THM 4T60-E HIGH TORQUE GEAR SET FOR 3.4L CHEVROLET

CHANGE: A new "High Torque" gear set is used ONLY in the 3.4L Chevrolet Engine model (Code

Figure 1

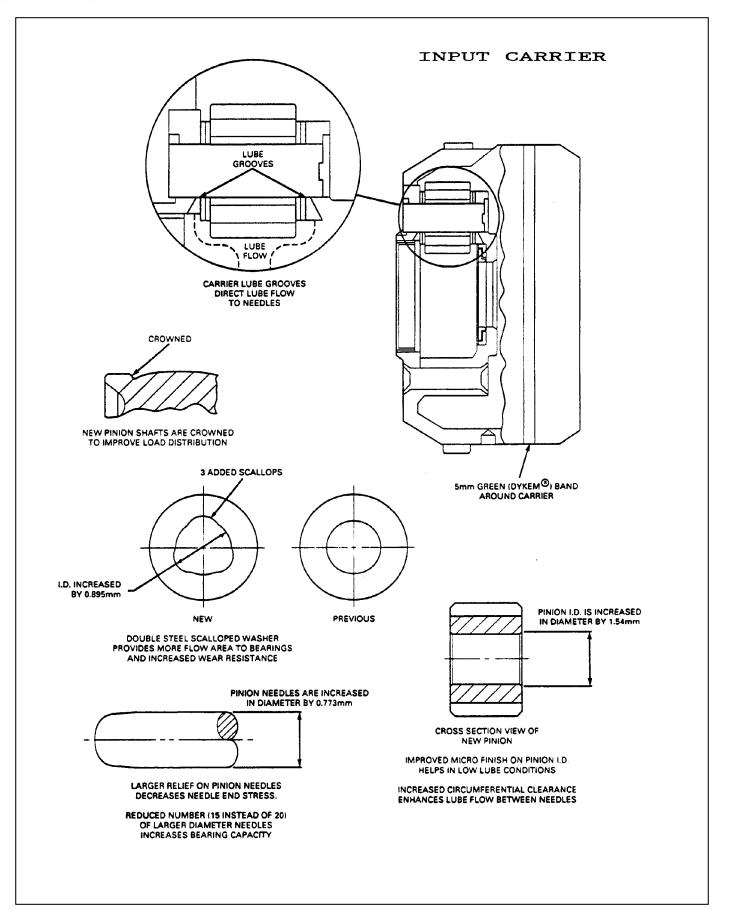
- (1) INPUT CARRIER New input carrier needles, pinions, pinion shafts, washers and lube grooves added to the carrier to increase lubrication through the needles. There used to be a bronze and a steel washer on each side of each pinion. Now, there are two new steel washers on each side of the pinion that have three' scallops or lube openings to help increase lube flow thru the pinion needles. The identifier for the "High Torque" input carrier is a wide green band around the outside of the carrier (See Figure 1).

Figure 2
AUTOMATIC TRANSMISSION SERVICE GROUP

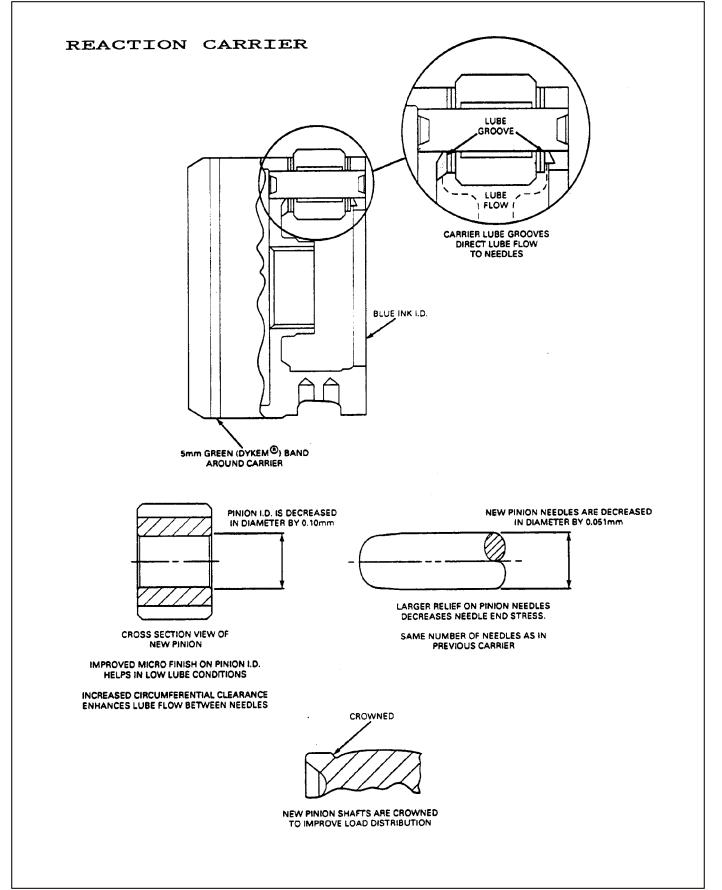
- (2) REACTION CARRIER New reaction carrier needles, pinions, pinion shafts, and lube grooves added to the carrier to increase lubrication through the needles. The lubrication flows into the lube groove slots in the carrier between the washer and the carrier, then through the needles. This helps get lubrication to the needles under high torque conditions. The identifier for the "High Torque" reaction carrier is a wide green band around outside of the carrier (See Figure 2).

Figure 3

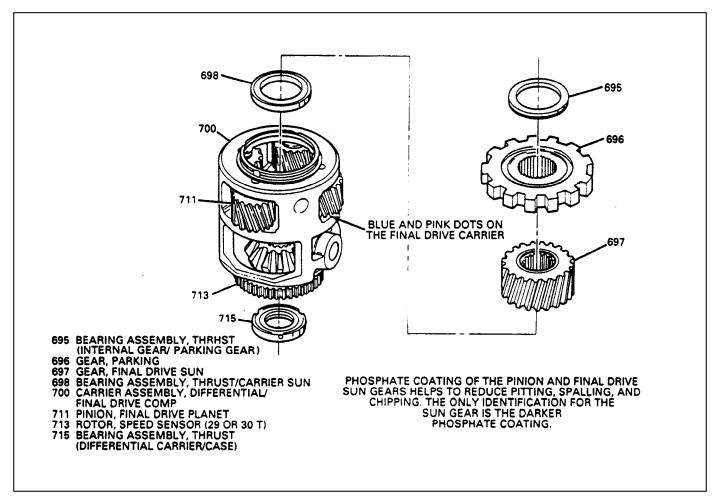
- (3) FINAL DRIVE CARRIER New final drive carrier has phosphate coated pinions (Darker Black Color) to reduce spalling and pitting under high torque conditions. The identifier for the "High Torque" 3.06 ratio final drive carrier is a blue dot and pink dot located on the carrier by one of the pinions. (See Figure 3).

- (4) FINAL DRIVE SUN GEAR,-, New final drive sun gear has a phosphate coating (Darker Black Color) on it to reduce spalling and pitting under higher torque conditions. The only identification for the 3.06 ratio sun gear is the darker black phosphate coating (See Figure 3).
